NOTICE OF VIOLATION

On January 29, 2025, Energy Safety conducted an inspection of Southern California Edison Company's WMP initiatives in the vicinity of the city Santa Barbara, California. The inspection report is enclosed herewith. Energy Safety found the following violation(s):

Violation 1. Energy Safety observed that in implementing 2024 WMP initiative 8.1.2.1.1 - Covered Conductor (SH-1), SCE failed to provide accurate data in reporting that covered conductor was installed on Pole ID 1523768E, Grid Hardening ID TD1966279-1523768E, at coordinates 34.464107, -119.711175.

INSPECTION REPORT

Structure ID: 1523768E

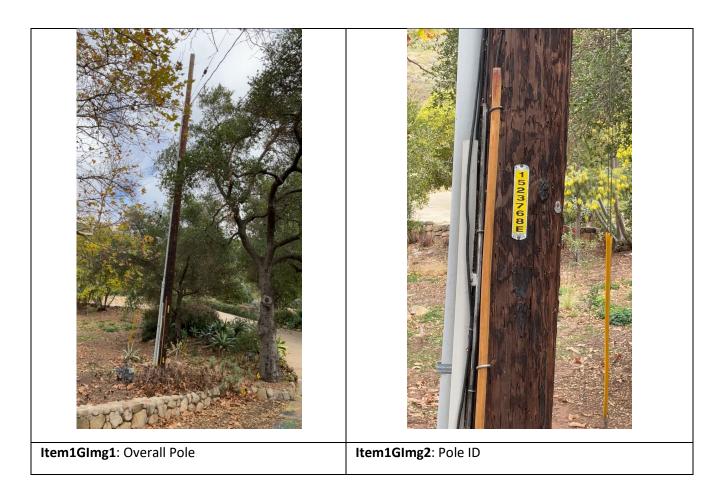
On Pole ID 1523768E, Grid Hardening ID TD1966279-1523768E, at 1458 Tunnel Rd, Santa Barbara, CA, coordinates 34.464107, -119.711175, the inspector observed that no covered conductor was present. The inspector's observation is documented in Violation 1 photographs, which are attachments to this report. Photo numbers Item1IA1Img1, Item1IA1Img2, Item1IA1Img3, and Item1IA1Img4 depict that no covered conductor was installed at the location. Per the 2024 2nd quarter Quarterly Data Report, SCE indicated that the covered conductor work was completed at this location.

Item1IA1Img1: No covered conductor observed
